Firmware

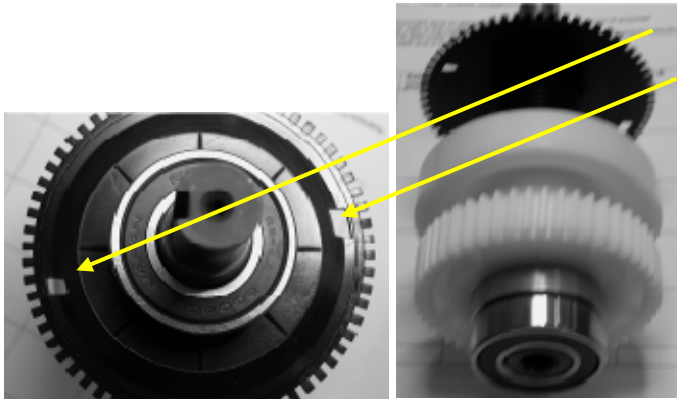
A new style encoder wheel is being implemented along with CB11 firmware version 40.

These models can easily be identified by looking at the firmware version or the encoder wheel itself. The new encoder wheel has 2 index notches as the older one has just one.

Using control boards that have older versions can cause problems if a sensor is required. Any adjustments for single index encoders must be performed using version 38 or earlier. In this way either style of chopper wheel can be used.

EMC Terminal PCB:

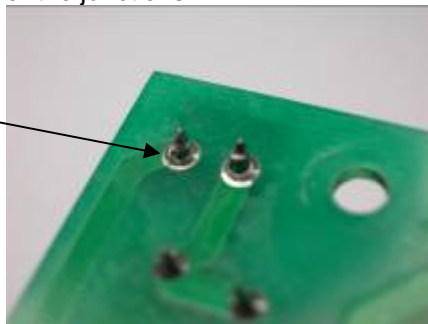
Some units have been identified with physical damaged to the 240V input terminal on the EMC3.02 PCB.

Symptom: No power to unit

Cause: Factory physical damaged at 240V input terminal on EMC filter board caused by driving screw driver with extra force.

The solution is to resolder the junctions.
